# OVERLOT GRADING, POND SR4 & UTILITY CONSTRUCTION DOCUMENTS

## FALCON MARKETPLACE

ISSUE	DATE
1ST SUBMITTAL	6-20-17
RESUBMITTAL	8-13-18

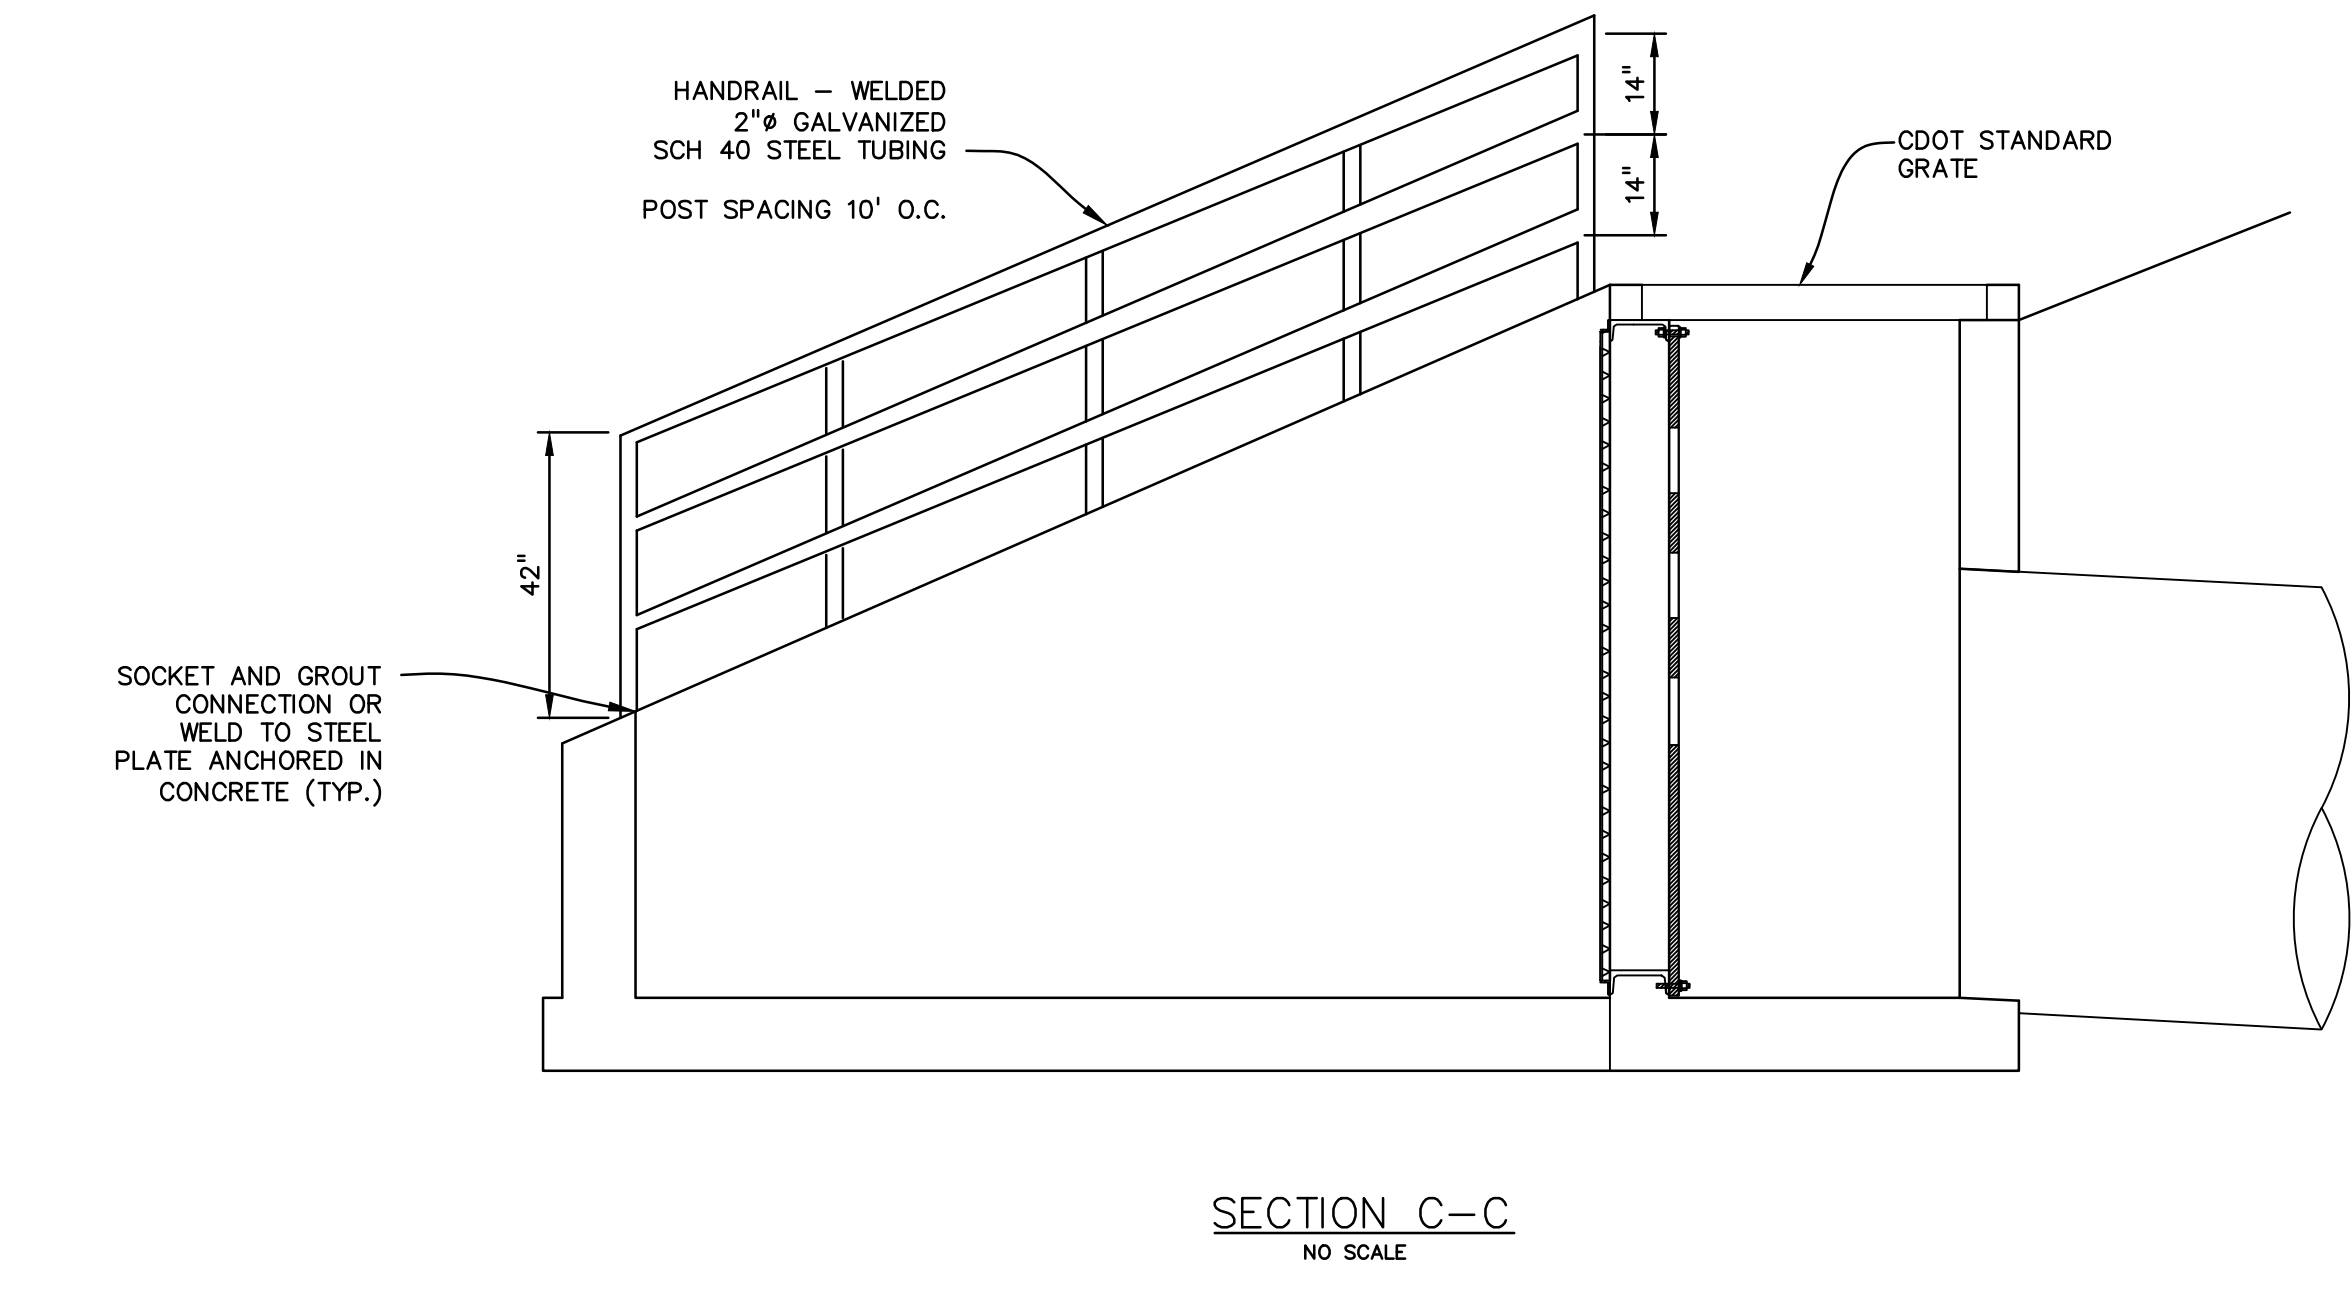
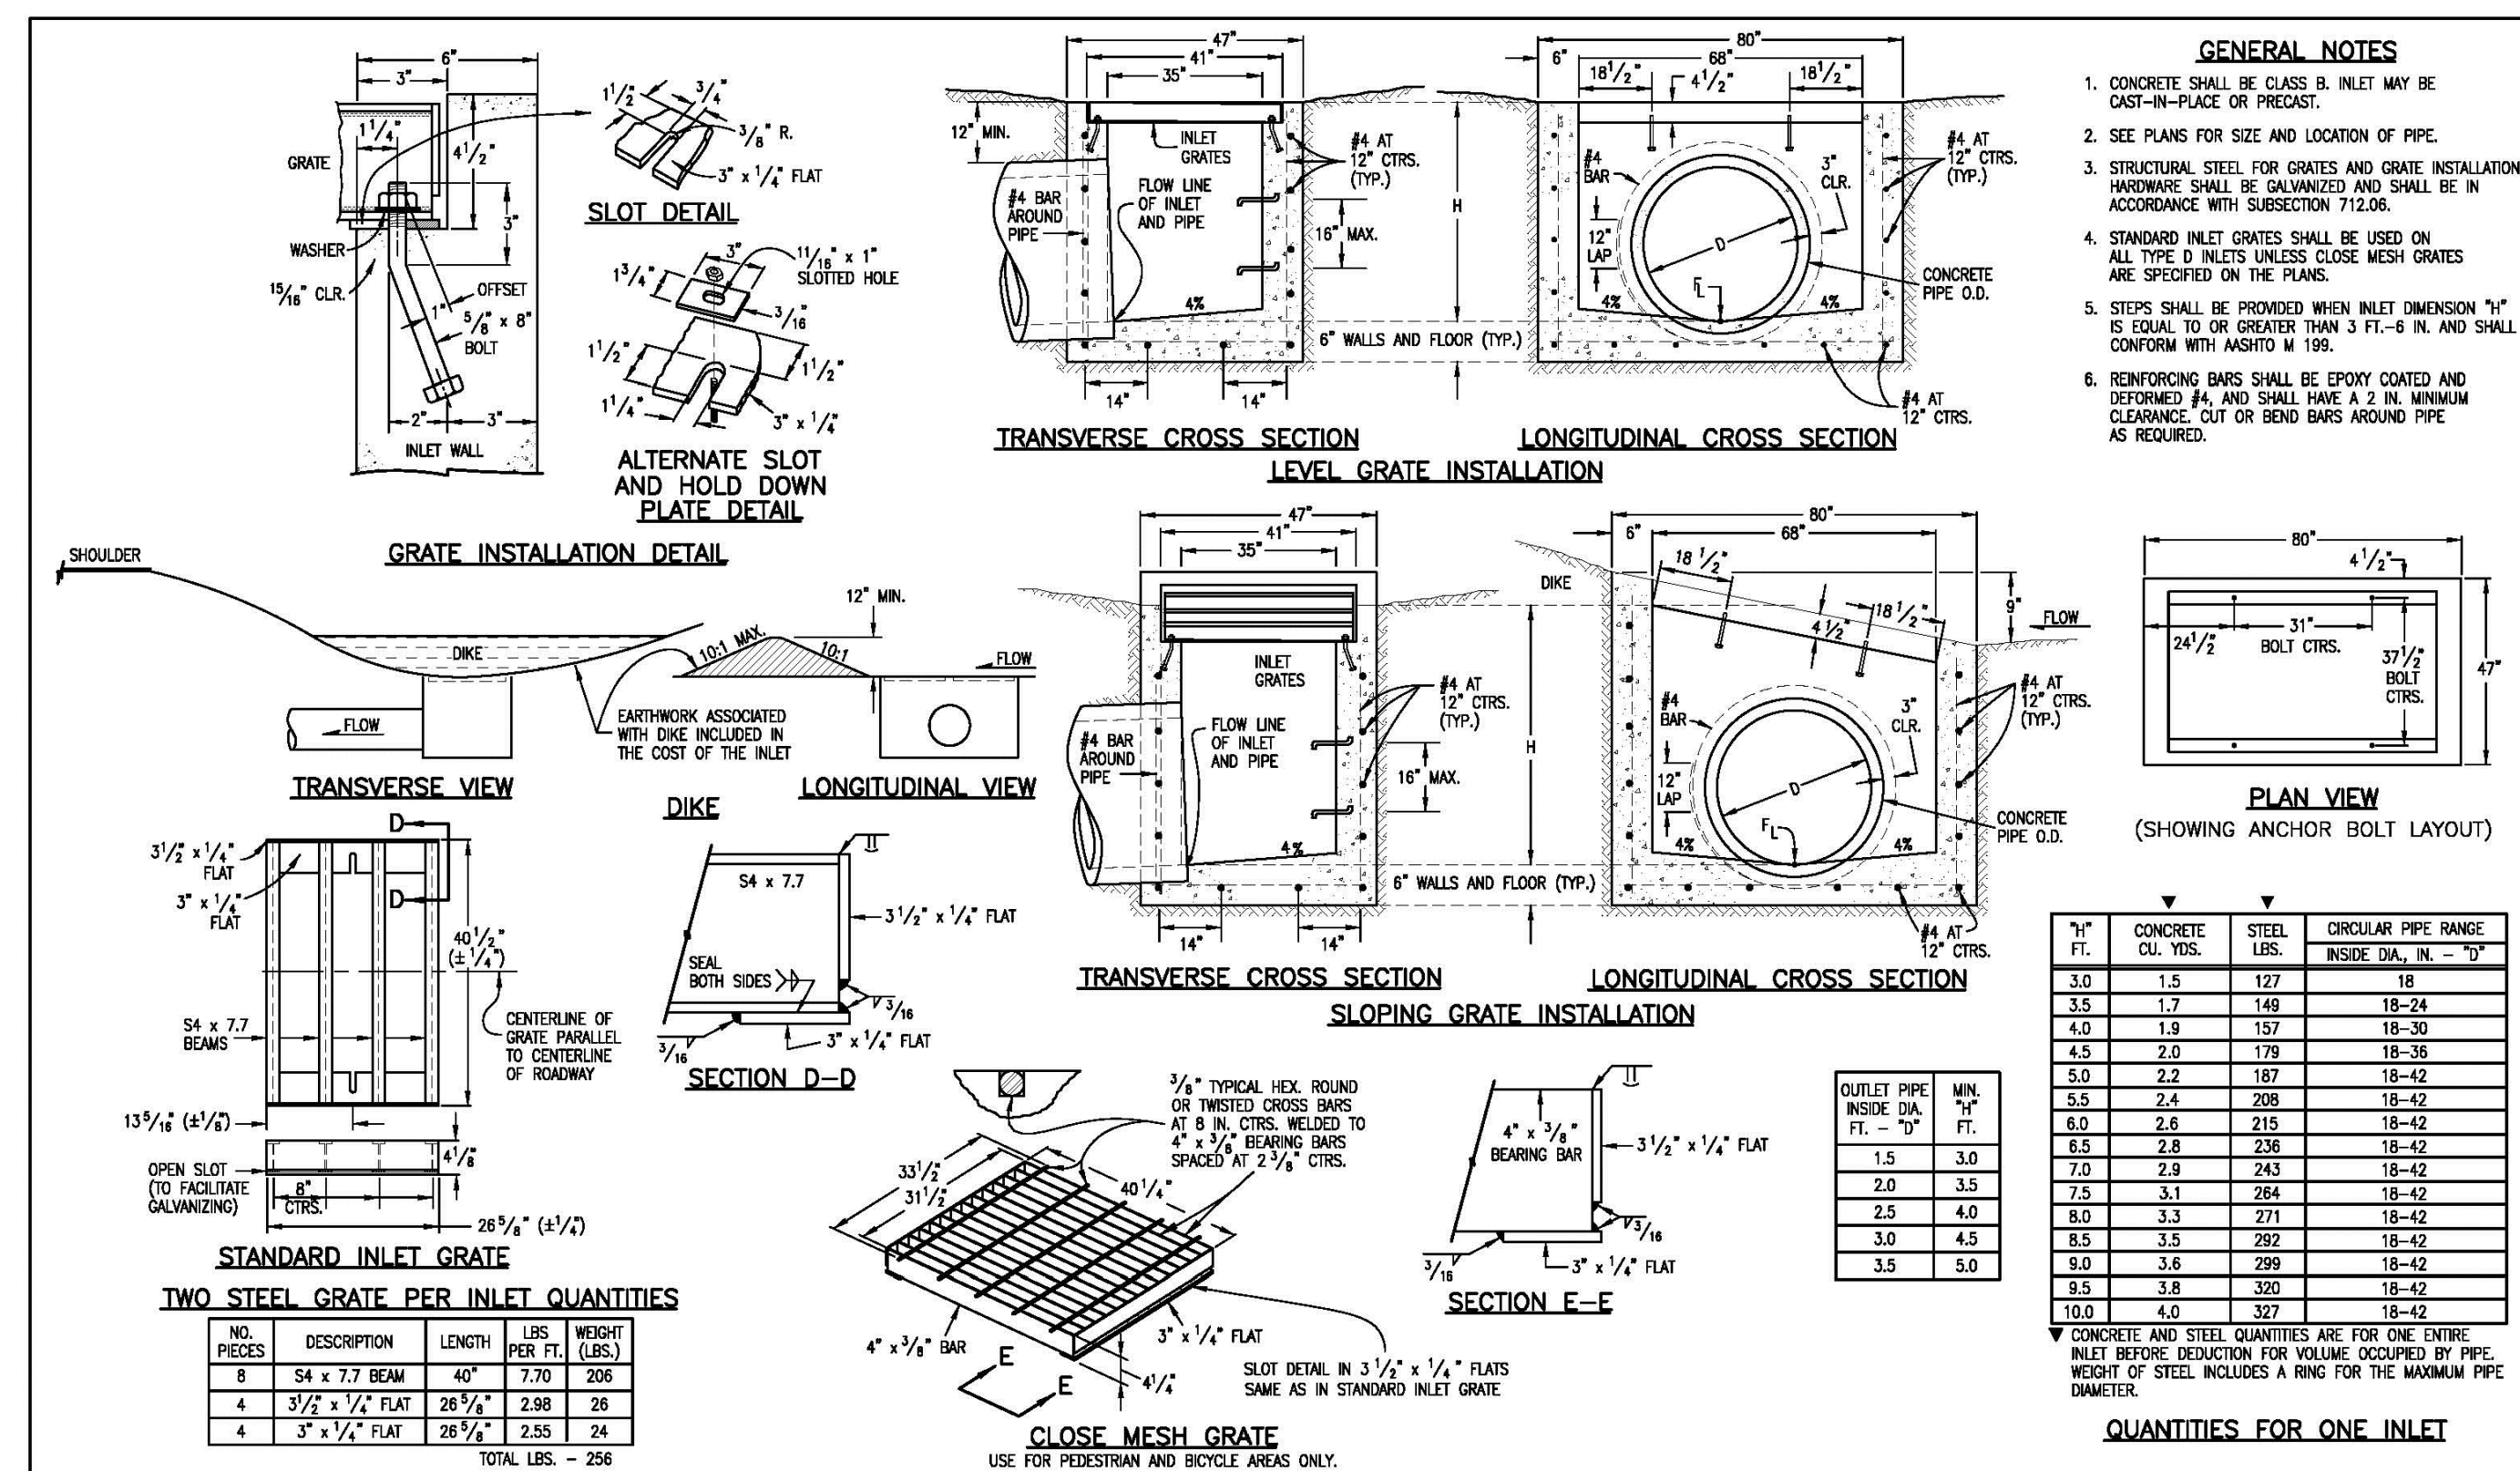
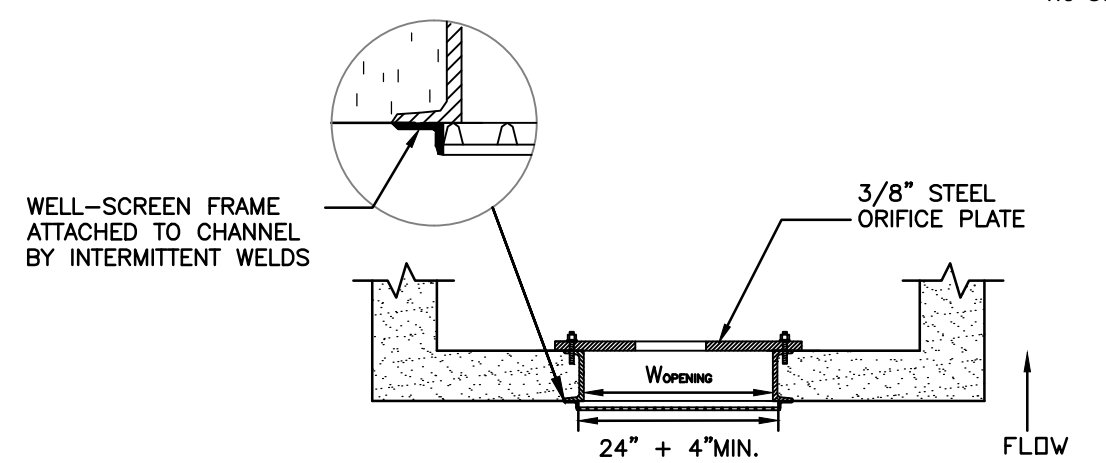
? - Clarify what will be coated (not stainless steel)
